The Commission has issued the enclosed Amendment No. 36 to Facility Operating License No. DPR-26 and Amendment No. 10 to Facility Operating License No. DPR-64 for the Indian Point Nuclear Generating Units Nos. 2 and 3, respectively. These amendments consist of changes to the Technical Specifications in response to your applications transmitted by letters dated July 20, 1977.

These amendments incorporate fire protection Technical Specifications on the existing fire protection equipment and administrative controls at your facilities, which were agreed to by your staff in discussions with the NRC staff.

INDIAN POINT NUCLEAR GENERATING UNIT NO. 2

Amendment No. 36
License No. DPR-26

Figure 6.2-1 Facility Management and Technical Support Organization

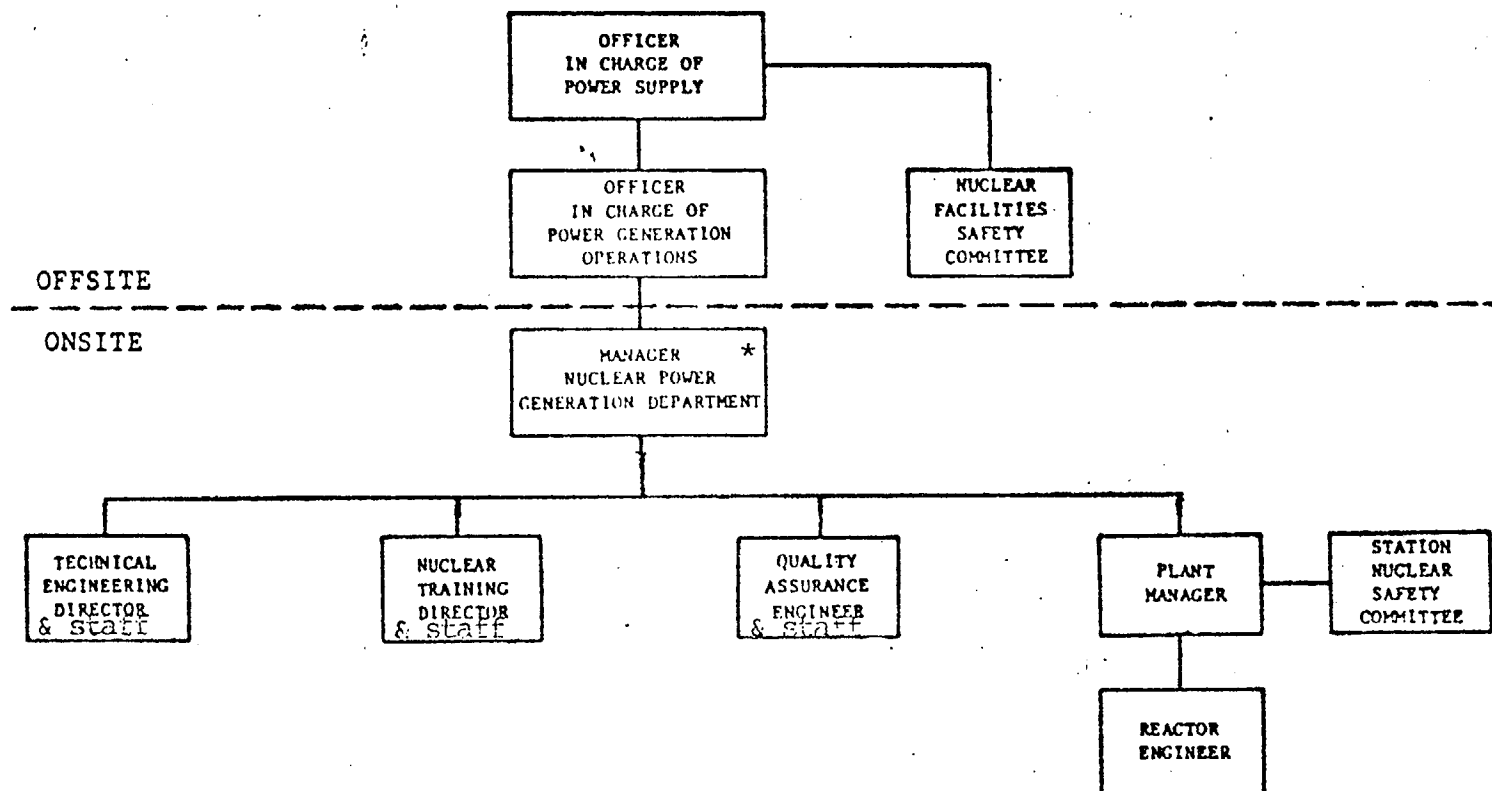
6.2.1 The organization for facility management and technical support shall be as shown on Figure 6.2-1.

* Responsible for performance and monitoring of the Fire Protection Program
